Arlington High School Building Committee Finance Subcommittee Meeting Thursday, February 17, 2022 Conducted by Remote Participation 4:00 PM – 5:00 PM Agenda

2/17/2022 AHSBC Finance Subcommittee Meeting Meeting Materials

Change Order (CO)

Massachusetts Avenue, Arlington, Massachusetts Revision to Sect 6 on S6.2.4 - Updated Relieving Angle Elevation

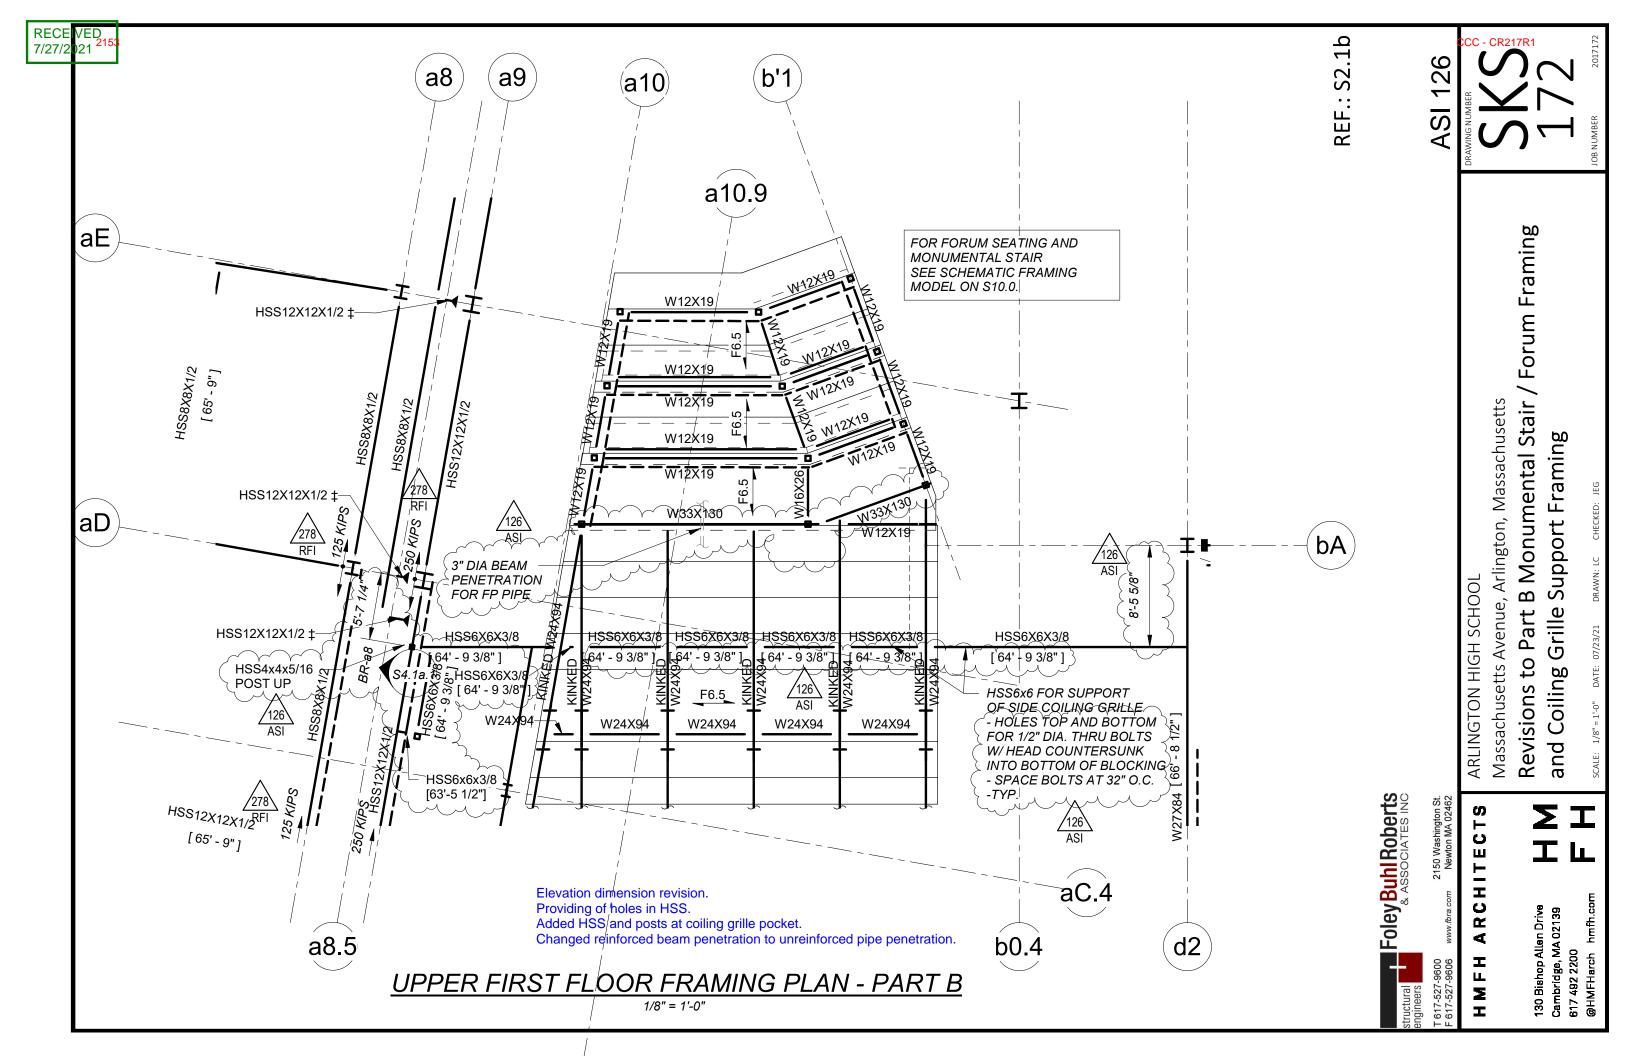
(a10) a8 a8.5 a10.9 \$5,2.1 (aD)/126 /ASK aC.4 (aC)Added post a8.5

Slab-edge plate notation change

REF. DWG. M3.2d RFI-342.3

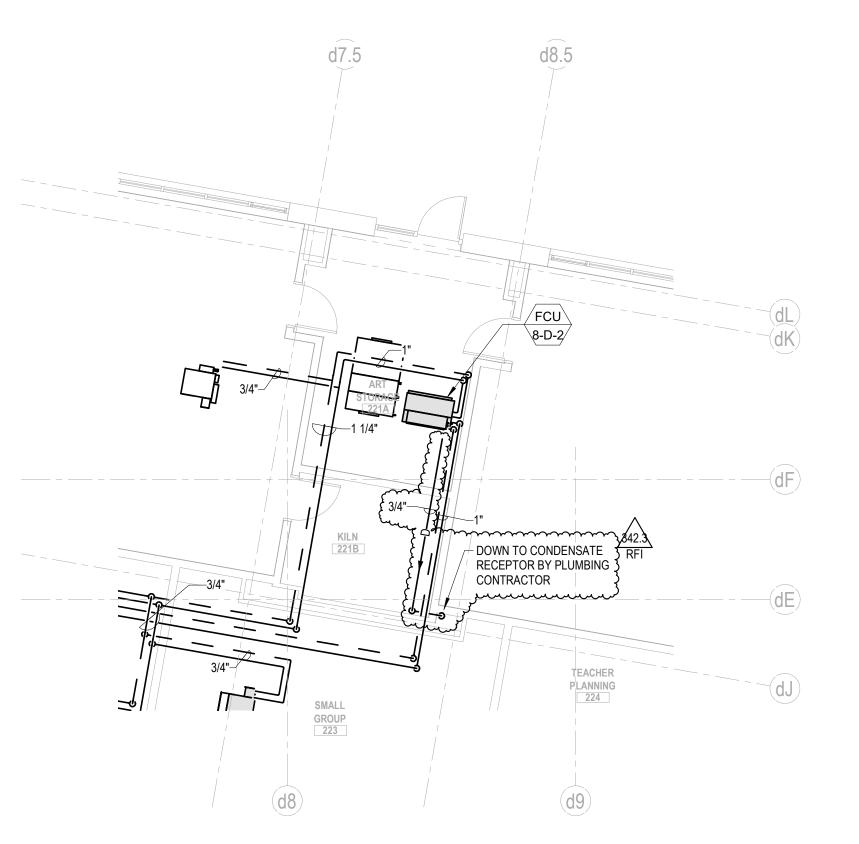
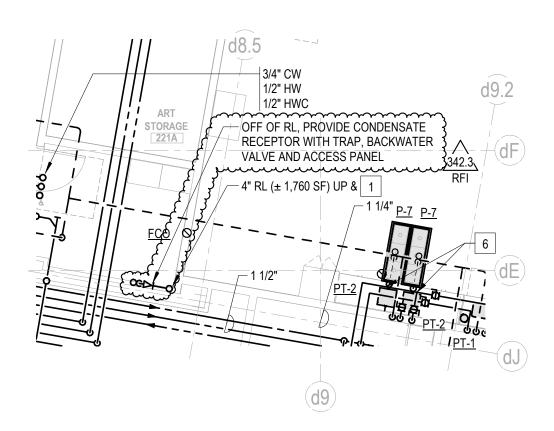
We are in receipt of RFI #342.3 – Condensate piping receptor at storm pipe issued by HMFH 9/22/21.

This RFI response will have a cost impact to add this condensate receptor piping behind the drywall to allow the connection to the storm drain.

Please reference HVAC Drawing M3.3b.

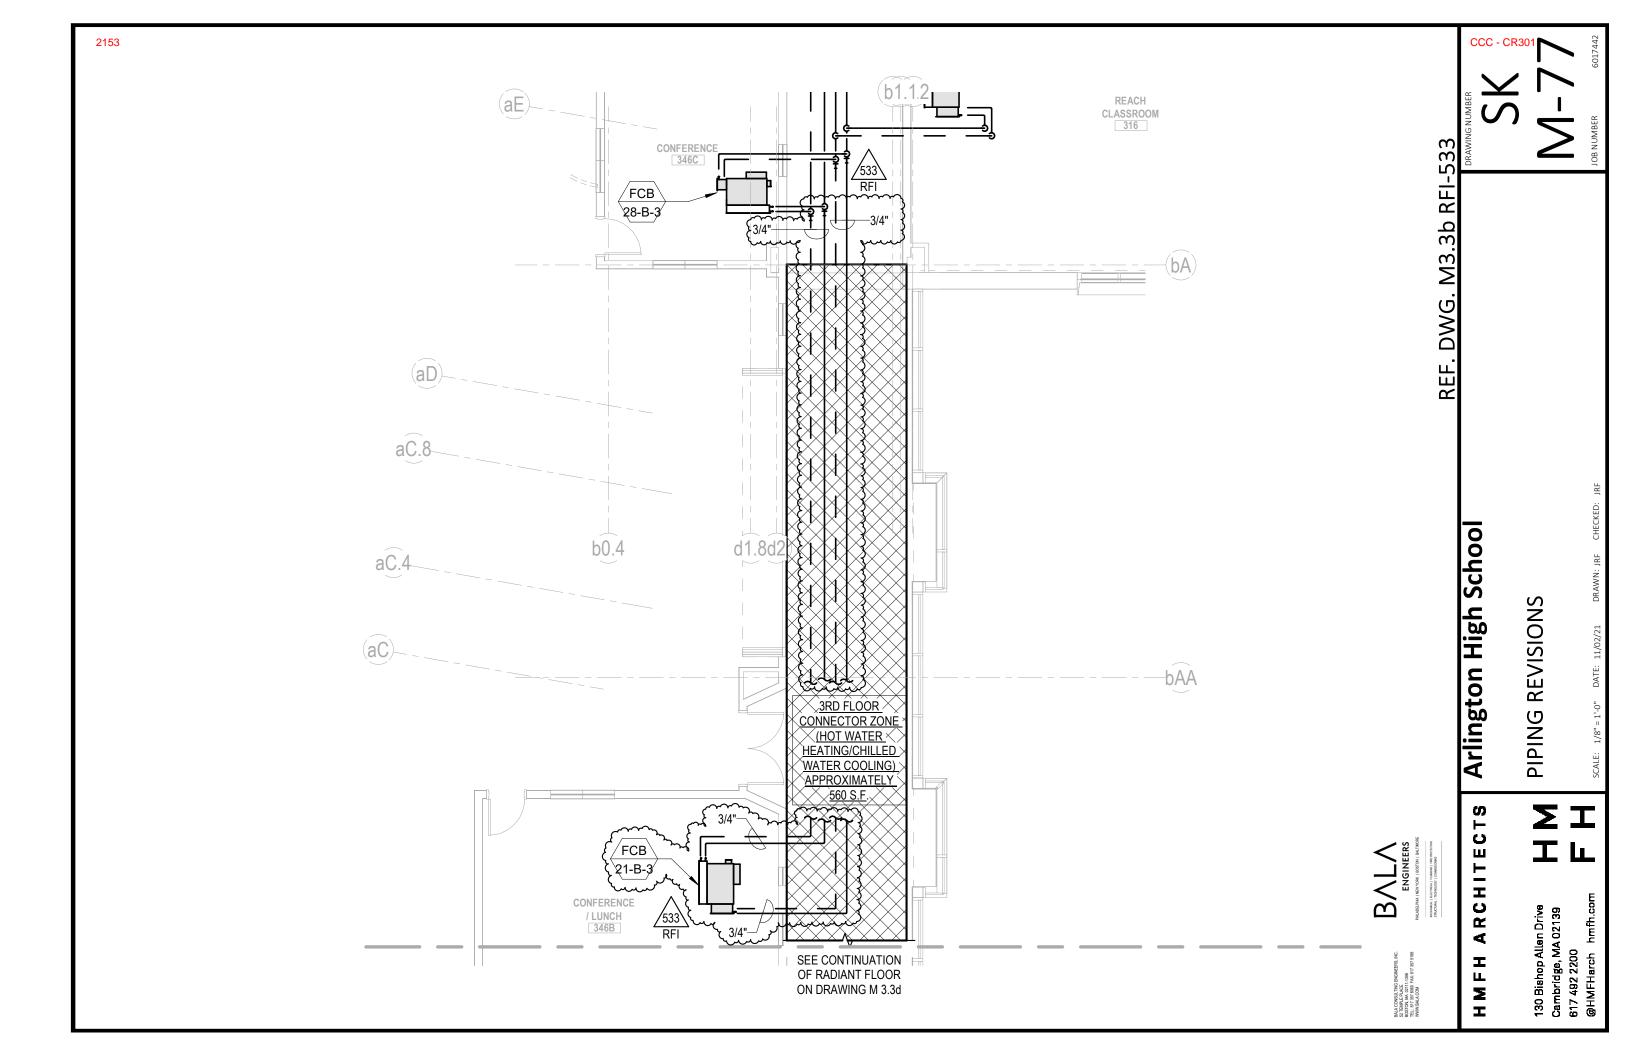
Typically the Fan Coil Boxes have Hot Water and Chilled Water Supply/Returns serving the equipment. HVAC Drawing M3.3b does not show pipe going to FCB-21-B-3, and it is believed the equipment is intended to have pipe going to the equipment.

Please confirm whether or not the HVAC Pipe is needed. Please provide a sketch for the intended design.

Please add hot and chilled water piping to FCB 21-B-3 as shown on attached Sketch SKM-77

TYP DRESSING RM - A 1/4" = 1'-0"

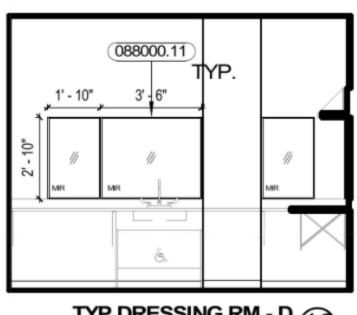
Please RFI room 241, 242, 243 dressing rooms outlets placement are in conflicts with mirrors. See notes below.

FIRE PROTECTION AREA D REVISIONS

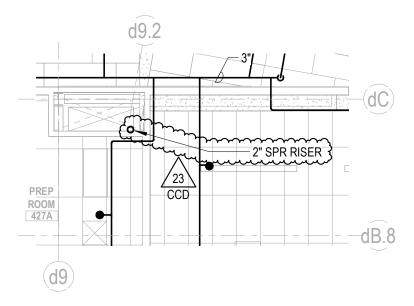
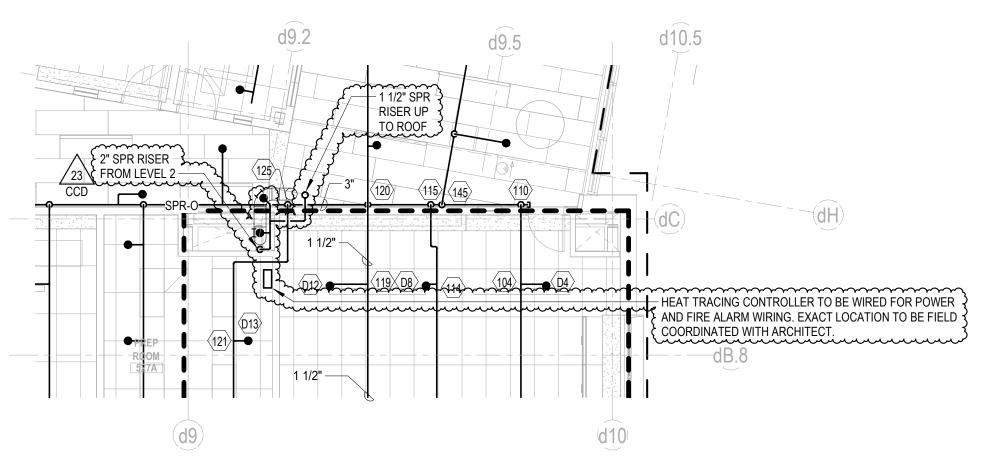
**CR147.1 includes revised Delta Mechanical pricing only in response to HMFH CR147 comments. CR147.1 has been issued to capture fire protection costs only. Costs associated with HVAC, Electrical, and Drywall scope were previously submitted and approved under CR147.

Please reference the attached PJK RFI #75. Please reference HVAC Drawing M4.1 and the associated Electrical Drawings E2.2e and E2.0b.

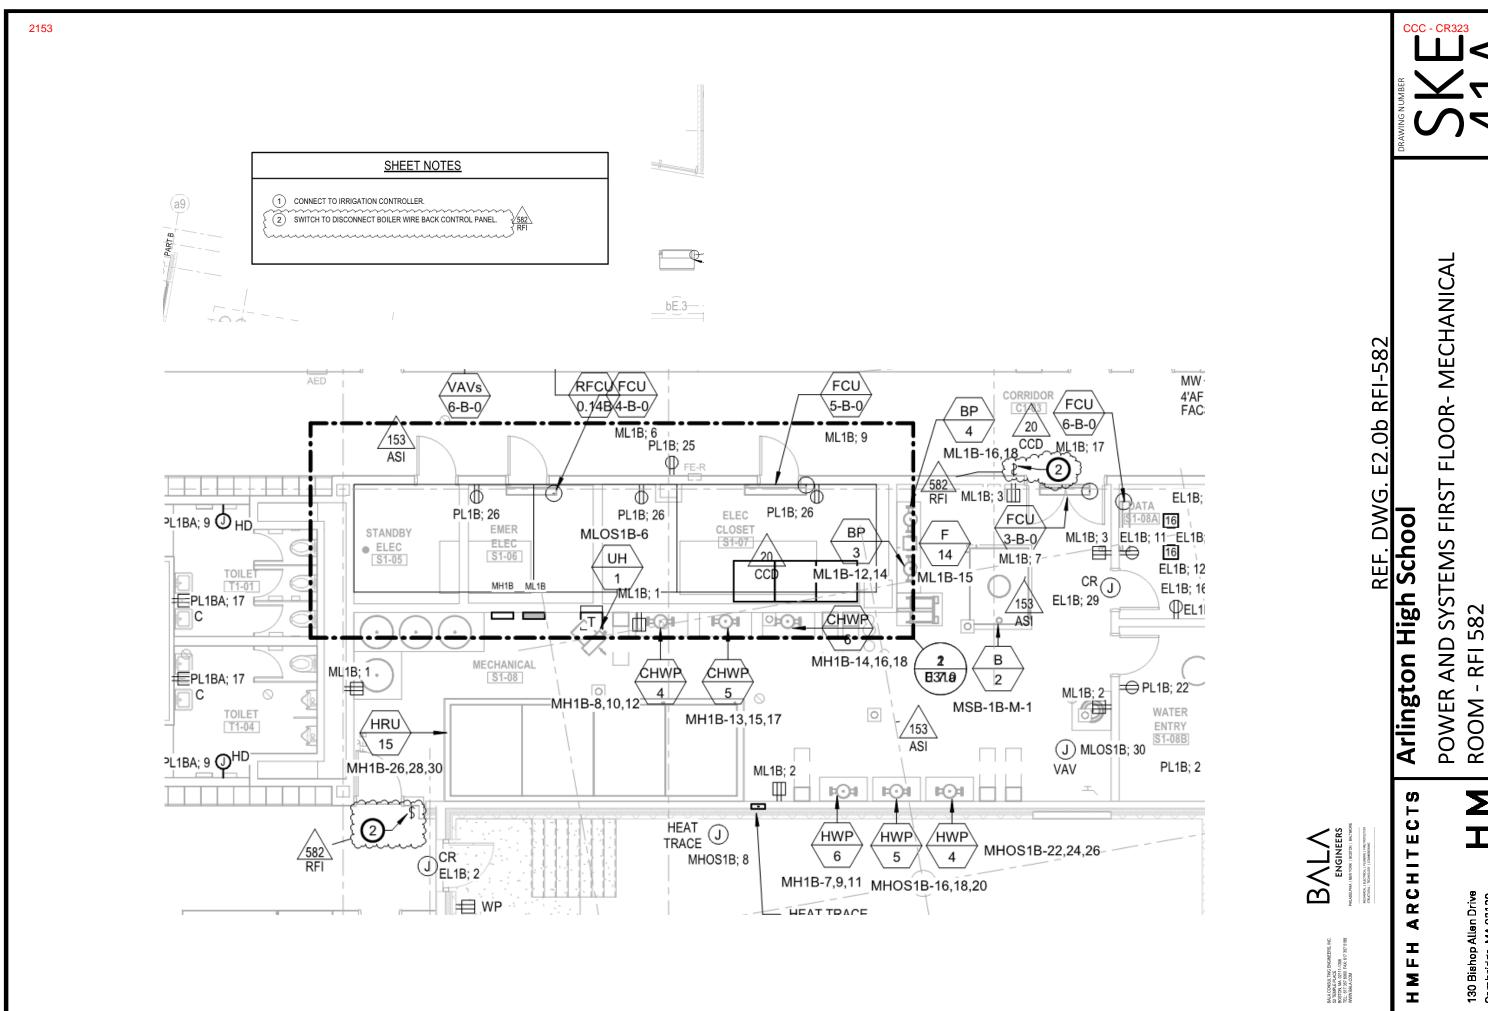
Emergency Disconnect Switches for Electric Boilers are required and should be added at both Mechanical Rooms. Refer to attached Sketches SKE-41A & 41B. Switches shall be push button type with "Emergency Boiler Shut-Down" text on device (by Pilla Electrical Model BSD120 or equal) installed in approximate locating shown at an elevation of 48" above finished floor. Switches located in common corridors shall be provided with tamper-proof plastic transparent covers.

The switch at Corridor C2-15 is to be located centered within the width of tile between doors S2-14 and 240.2.
